## MEMORANDUM

To: Village of Cold Spring Planning Board  
From: Chuck Voss, AICP  
Re: Butterfield Site Plan – Realignment of Bldgs. 1 & 2  
Date: December 19<sup>th</sup>, 2014

The purpose of this memo is to provide a brief summary of the possible realignment scenarios for Buildings 1 & 2 on the Butterfield Redevelopment site plan, and provide some technical analysis of the preferred alternatives selected by the Planning Board.

Option "Z"

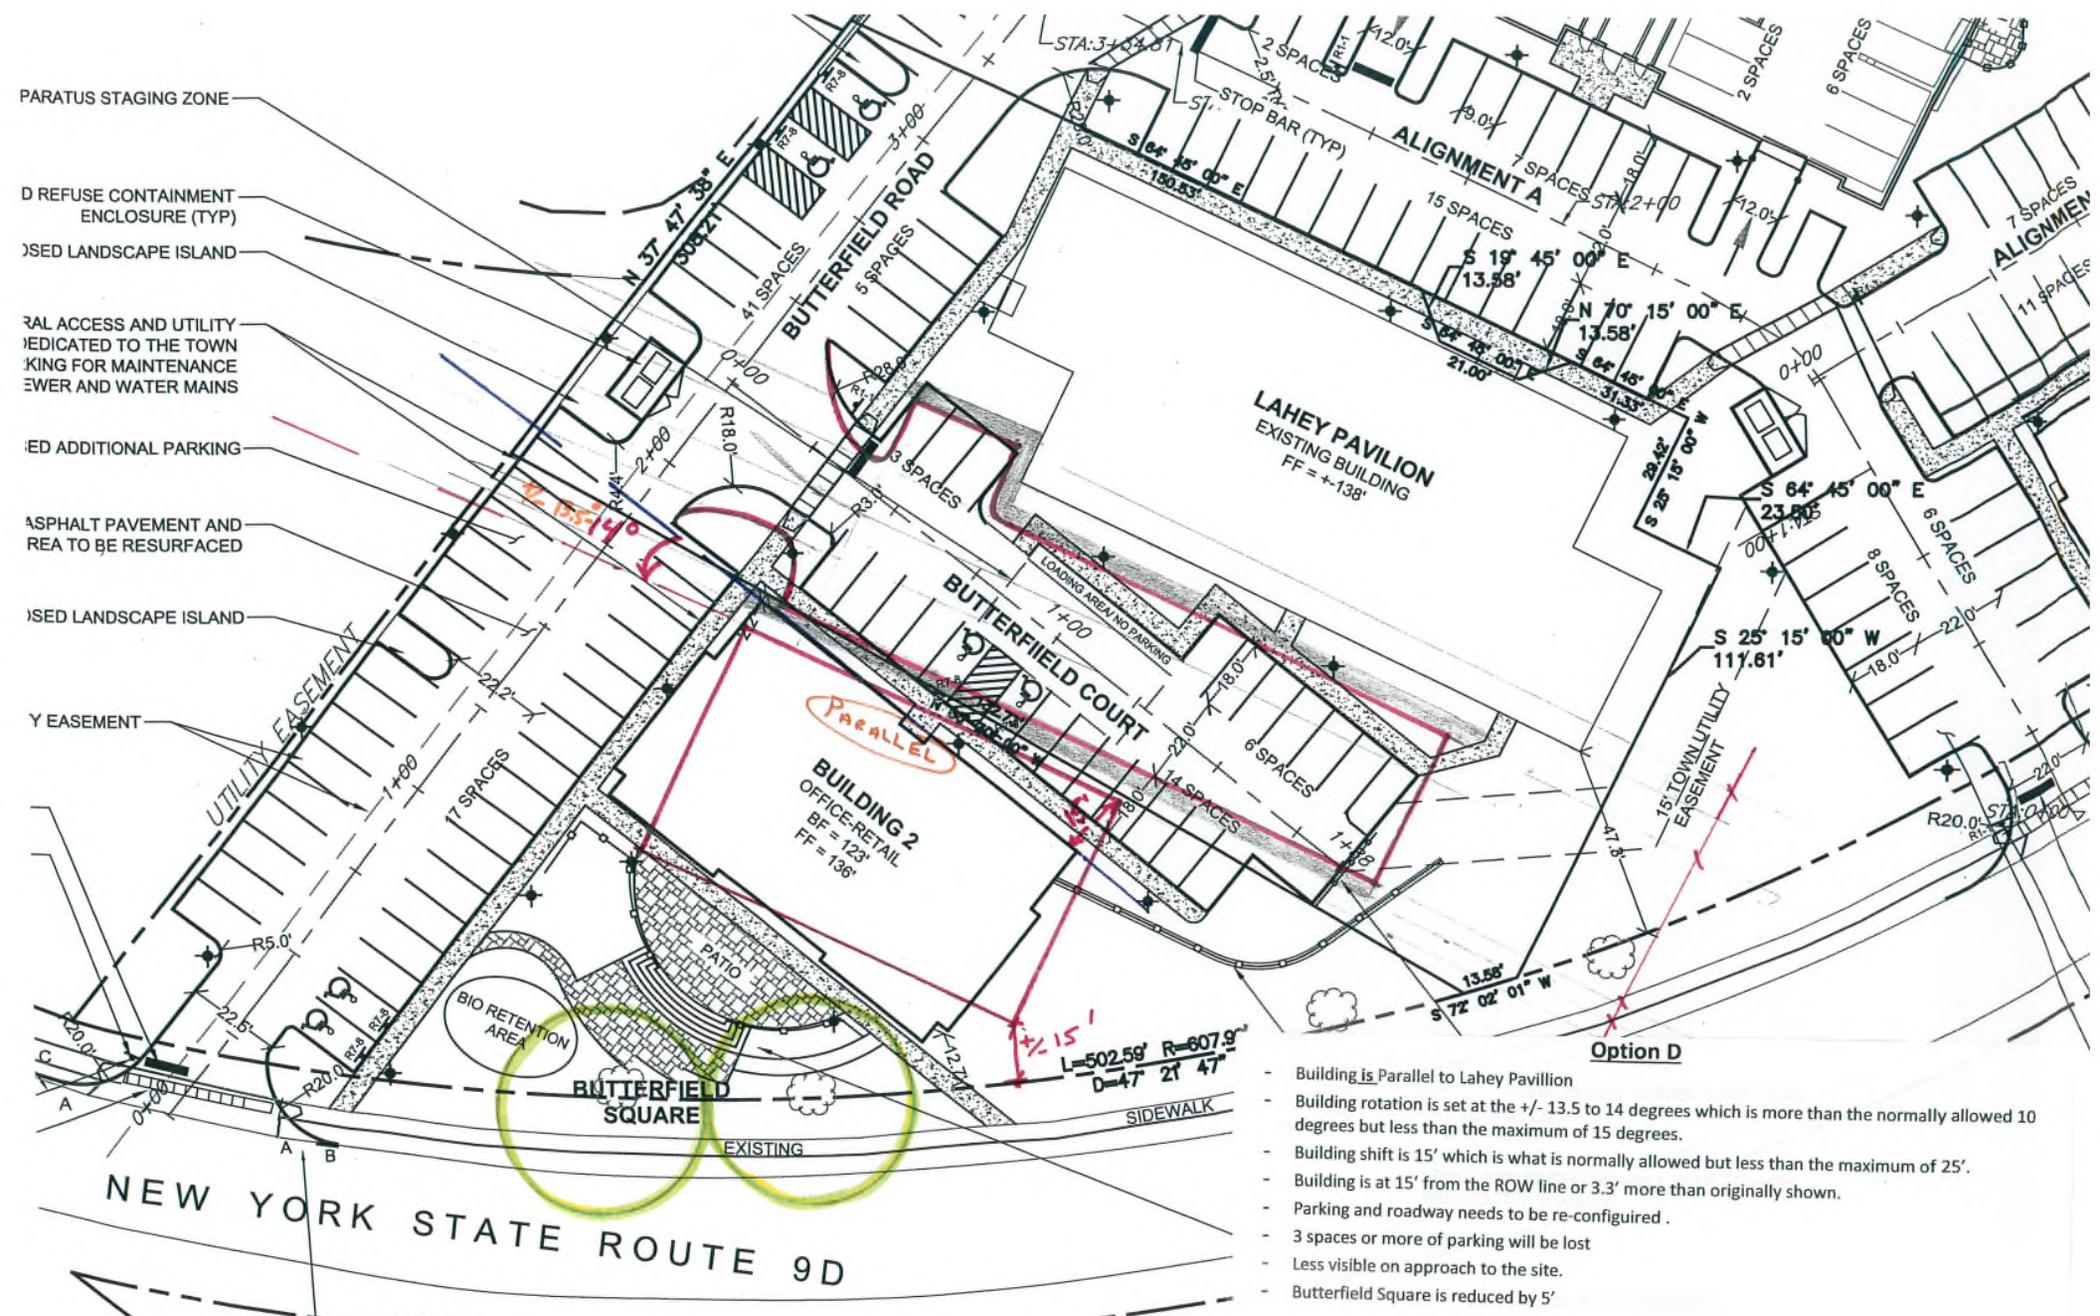
In reviewing the preferred repositioning scenario (Option "Z") for this project, we offer the following comments:

- This option complies with §134-15A 5 (c)(d) of the B4A code, and does not exceed the maximum allowable shift in angular repose (15\*) or the maximum lateral repositioning (25').

- No variances from the B4A code are required to achieve this preferred redesign scenario.
- Of all the options offered for the repositioning of Building #1, this option maintains the greatest setback (22'-25' +/-) from the Route 9D edge of pavement. Maintaining maximum setbacks of all new proposed buildings along Route 9D conforms to the expressed design preferences of the HDRB.

- Minimal redesign of immediate and adjacent amenities would be required under this scenario as opposed to the other two scenarios, which would require extensive redesign. The repositioning of Building #1 under this scenario will require some minor redesign of various elements such as surface parking spaces, curbing, pedestrian sidewalks, stormwater management facilities, and landscaping.

- It is not anticipated under current plans that this realignment scenario will necessitate the relocation or redesign of any primary infrastructure systems or facilities such as sewer, water, stormwater, or other utilities.

- This option also does not create any negative impacts to site access onto or off of Route 9D, or internal circulation roadways. A previously proposed loading dock to service the commercial uses located along the northeast side of Building #1 will be lost under this scenario. However 4 new parking spaces are added resulting in a net positive increase in parking spaces adjacent to this proposed commercial building.

- If this repositioning scenario is implemented, opportunities for new pedestrian amenities (patio, outdoor seating area) and landscaping are available in the newly created space fronting on Route 9D adjacent to the east side of Building #1. Similar design elements as are proposed for the Butterfield Square and/or the bio retention/wetlands gardens just to the north of Building #1 should be incorporated into this new pedestrian plaza to create broader continuity of open pedestrian spaces across the whole site.

- This option, upon completion, will not cause any disruptions to the pedestrian or vehicular flow of the project in this general proximity, nor will it necessitate the repositioning of other buildings, structures or amenities.

- B&L supports this preferred realignment scenario because it represents minimal impacts to the approved Butterfield Redevelopment Concept Plan, conforms to the B4A zoning code and offers opportunities for enhanced site design.

- Net Building shift of 13' to the North from proposed location.
- Building 1 is set 2' from the Property/ROW line along left face.
- Building 1 is set 15' from the ROW/Property line along right face.
- Net Parking shift if 5' North
- (1) additional parking space created Via reconfiguring spaces and by removing Drop Off/Loading area
- Useful Plaza created.
- Note that closest face of building to Rt 9D would be about 25'
